Entergy Operations, Inc.
1448 S.R. 333
Russellville, AR 72802
Tel 479-858-3110

1CAN061201

SUBJECT: License Amendment Request
Technical Specification Change Associated with Main Feedwater Valves
Arkansas Nuclear One, Unit 1
Docket No. 50-313
License No. DPR-51

Analysis of Proposed Technical Specification Change

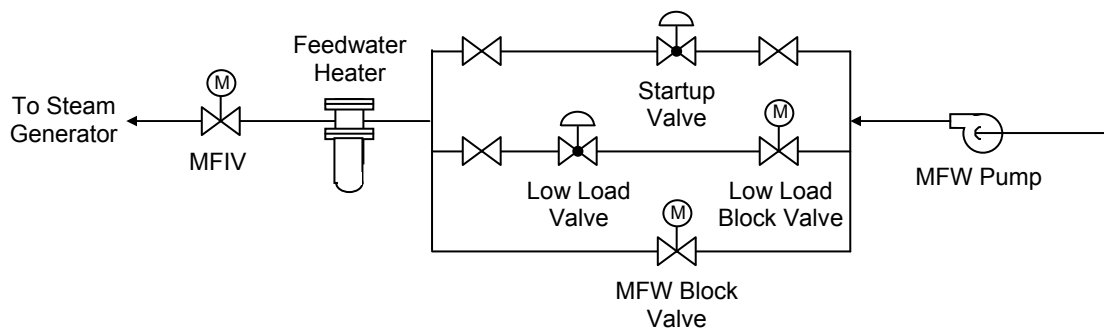
At lower power levels, SG level is maintained through modulation of the Startup and Low Load Feedwater Control Valves (see simplified drawing). The control valves are sequenced in operation so that the Startup Control Valve opens first, followed by the Low Load Control Valve. Differential pressure across the control valves is maintained through modulation of MFW pump speed.

When feedwater demand increases to approximately 50%, the MFW Block Valve opens, the Startup and Low Load Control Valve demands are held constant, and the MFW pump transfers from controlling valve differential pressure to directly controlling MFW flow. This sequence is reversed for power reductions, except that the MFW Block Valve closes at approximately 45% feedwater demand.

To ensure feedwater is isolated to the SG following a Main Steam Line Break (MSLB), a predetermined pressure set-point associated with a lowering SG pressure triggers an automatic Main Steam Line Isolation (MSLI) signal, which is initiated from the Emergency Feedwater Initiation and Control (EFIC) system. The MSLI signal closes the downstream MFIV. The Startup Control Valves, Low Load Control Valves, and MFW Block Valves close upon MSLI and/or reactor trip and the Startup Control and Low Load Control Valves are prevented from re-opening by the MSLI signal (not required for the MFW Block Valves since the reactor trip assures power is below 45% as described above). All of the aforementioned control and transient response functions are processed via the Integrated Control System (ICS), except those functions associated with the MFIVs.
